Work Order ID 105912

Item Name: Fwd Crosstube - High

DRAWING NO. D212-664-141	TITLE XTUBE ASSY (205/212/412 HI FWD)	REV. D	DART AEROSPACE LTD ENGINEERING ORDER	D.E.O. NO. D212-664-141-D-1	SHEET NO. SHEET 1 OF 2	SCALE NTS
DRAWN	CHECKED	OP	MFG. APPR. <i>ER</i>	APPROVED <i>MP</i>	DE APPR. <i>MP</i>	
DATE 11.04.07	DATE 11.04.11		DATE 11.04.12	DATE 11/04/12	DATE 11.04.12

D212-664-141/-141B
ASSEMBLY DETAIL

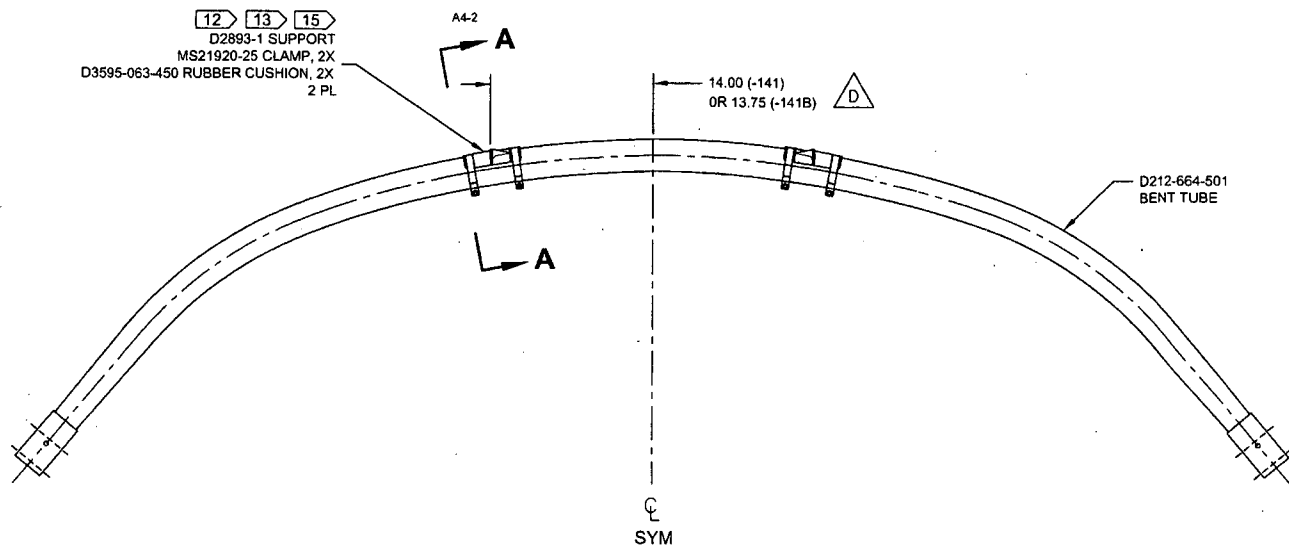
REMOVED FROM UNDER REVIEW PER
UNDER REVIEW EGNH 11-614
FOR SEALING SHEET

**D212-664-141/-141B
ASSEMBLY DETAIL**

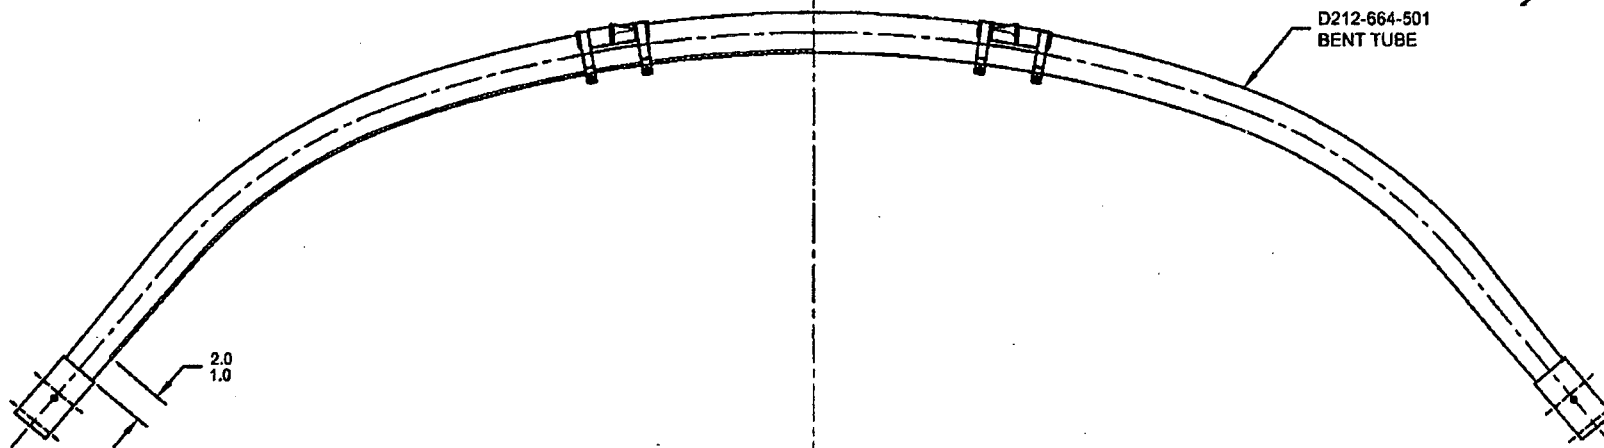
ADD AN INSPECTION WINDOW TO UNDERSIDE OF CROSSTUBE.

NOTES 2 OF SHEET 1 IS AMENDED AS FOLLOWS:

- 2) FINISH: CHEMICAL CONVERSION COAT PER DART QSI 005 4.1
PRIME INSIDE AND OUTSIDE PER DART QSI 005 4.2
MASK UNDERSIDE OF CROSSTUBE AS SHOWN (HATCHED AREA) AND
PAINT OUTSIDE PER DART QSI 005 4.2
REMOVE MASKING AND APPLY CLEAR COAT

MASK AREA PRIOR TO PAINTING.
REMOVE MASKING AFTER PAINT
AND APPLY CLEAR COAT
